**CORPORATION OF THE CITY OF
CLARENCE-ROCKLAND
PLANNING COMMITTEE**

Date	06/12/2017
Submitted by	Marie-Eve Bélanger
Subject	Official Plan Amendment, Zoning By-law Amendment, Subdivision - Brigil
File N°	D-12-121, D-09-82, D-14-493

**Subject: Proposed Draft Plan of Subdivision
Part of Lots 27-30, Concession 1 (O.S.),
Part of Lot D, Concession 8
Atrél Engineering Ltd. Agent for Brigil (3223701 Canada Inc.)
Your File No.: D-12-121**

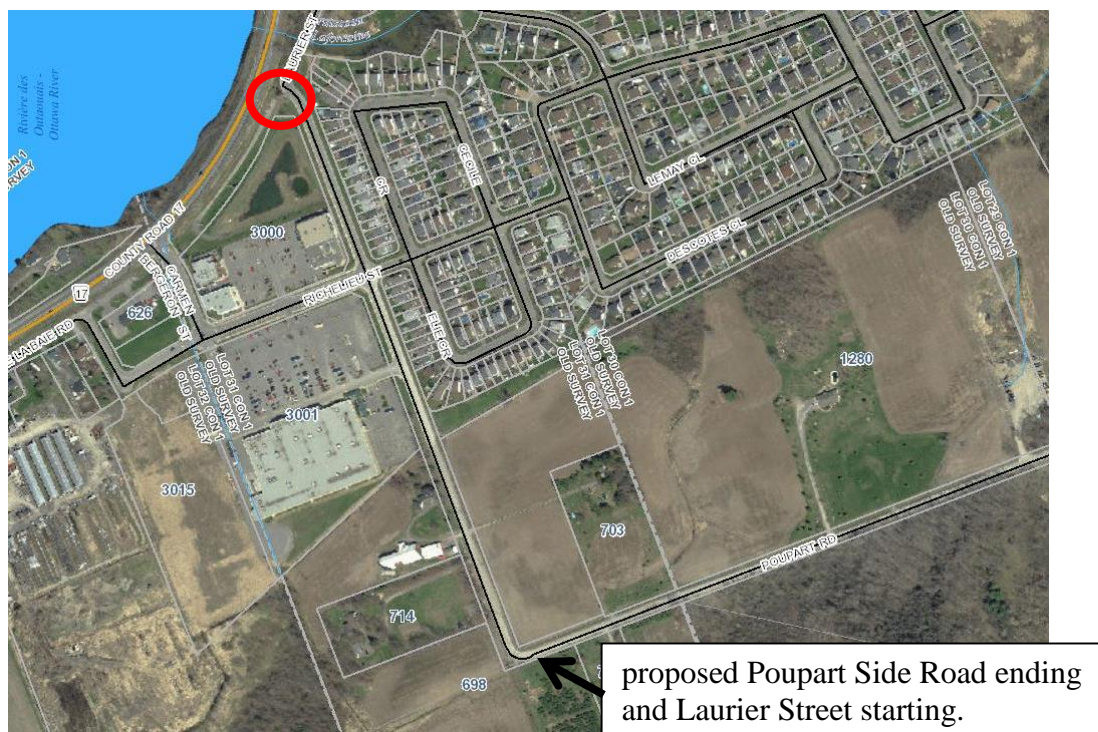
Poupart Side Road and St-Jean Street are considered collector roads under the City OP and County OP which requires a 26 metre right-way. However, it was indicated that Poupart Road and St-Jean Street could become the east-west road that would link County Road 17 to Caron Street, and that a right-of-way of 30 metres would be required. The Master Transportation Plan of 2005, the DC Study and the OP of the City speaks to the fact that an east-west road is required in the south end of the City. We now have County Road 17 and Laurier Street that acts as east-west collectors and the next one would be Poupart. We have also received the proposal for the Draft Plan of Stage 5 Morris Village which has a 26 metre collector that will connect to St-Jean Street at a roundabout at the bottom of the St-Jean hill. The current residents of Morris Village already uses Poupart Road to by-pass Rockland. We believe that the future residents of Stage 5 Morris will also be using this road.

As such, we recommend that Poupart Side Road and St-Jean Street be widened to 30 metres. Therefore, 15 metres from the centreline of the road will need to be transferred to the City for Poupart Road and to the Counties for St-Jean Street. The developer would be responsible to design and build Poupart Side Road and St-Jean Street fronting their properties. The developer would be reimbursed using the Development Charge money reserved for that project.

The City will be completing a preliminary design for Poupart Side Road in 2018. The study will take into consideration the design that will be completed for Poupart Road and will include recommendations in regards to the intersection improvements, traffic impacts, transit impacts and how the proposed streets will connect to Poupart.

The design that the City will be undertaking will include sidewalks, bike lanes and/or multi-use pathway along Poupart/St-Jean Street..

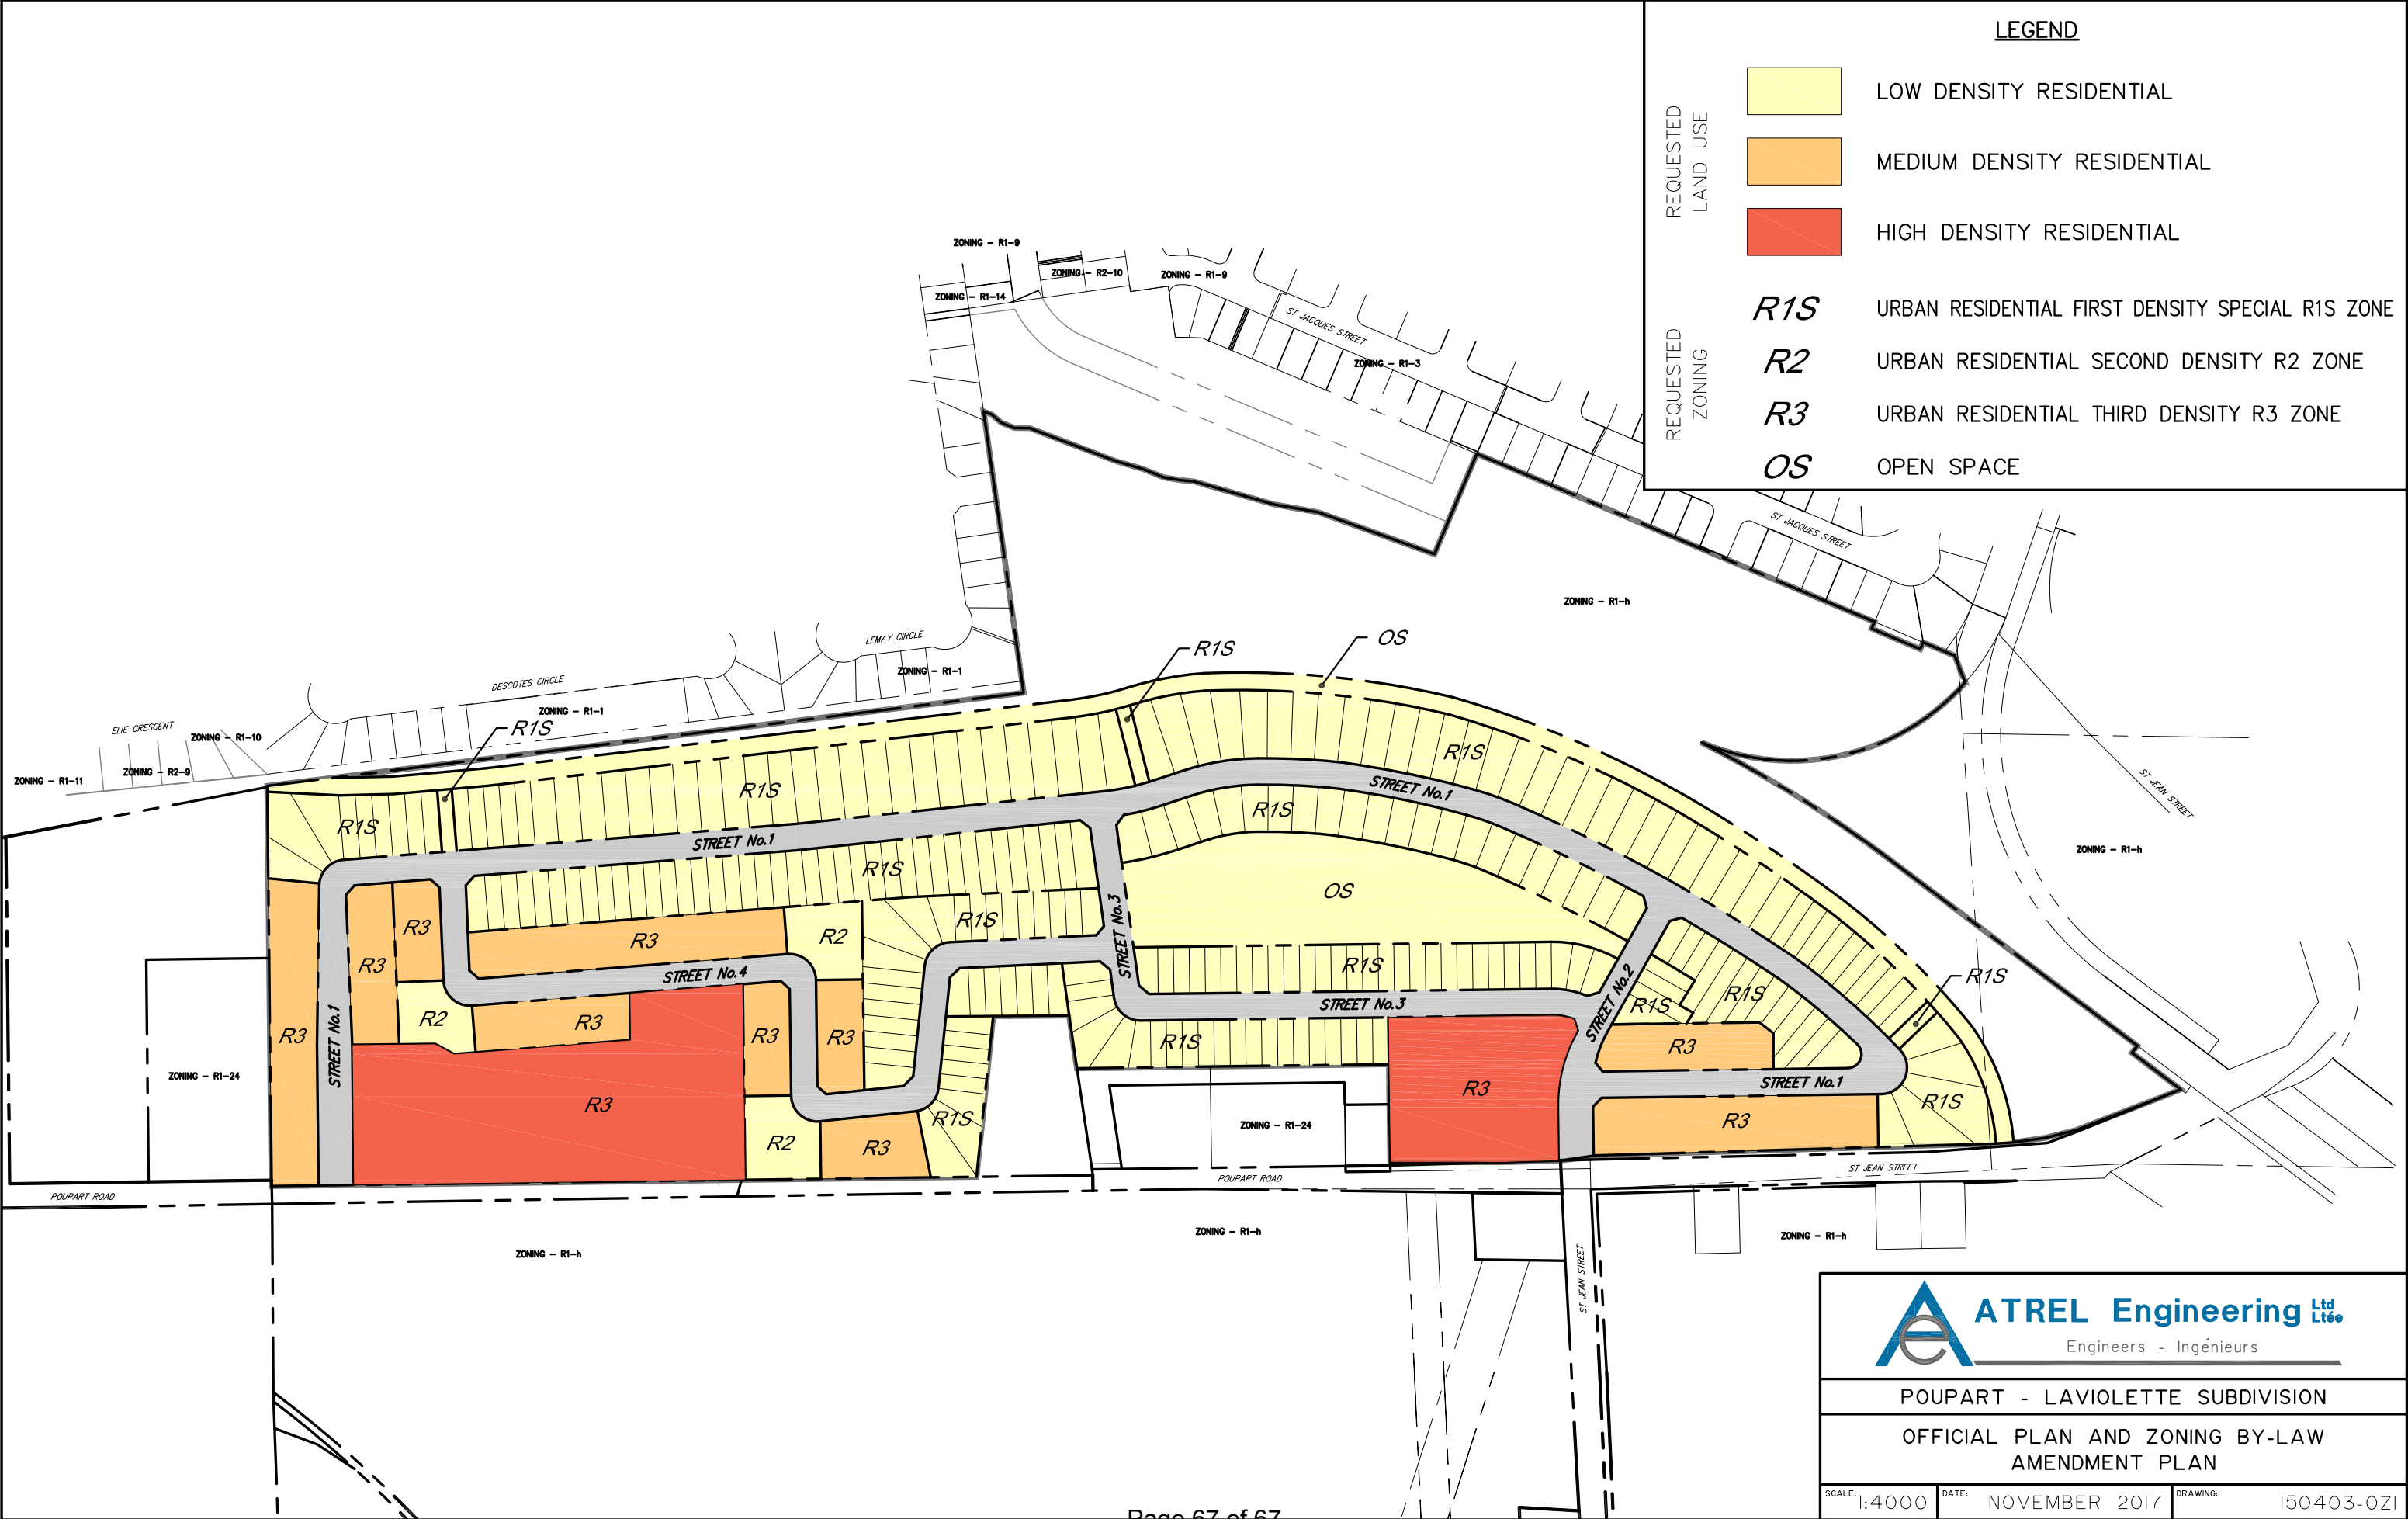
Since the municipal council gave permission last year for 4 six phases to be built right next to the existing sidewalk on Caron street; this means ~~now~~ ~~me~~ that Caron street will not be made into a 4 lane road and therefore the amount of people in the future living at the south end of Caron street near Baseline road will need another east, west multi lane road to get them to Wal-Mart and to Old Highway 17.

Baseline ~~me~~ road cannot be that road because of the dangerous hill between St Jean and Caron streets.

The new road should be about half way between the electrical plant next to Poupert road and St-Jean and the second hill. If this is done then there will be no large hills on this future road but a reasonable incline.

Now, Poupert road going west starting at the east part of the proposed High Density residential should become a 4 lane road. A storm sewer needs to be installed to replace the deep ditches and the dangerous 90° curve needs to be addressed and also the ~~width~~ width of the road needs to be addressed.
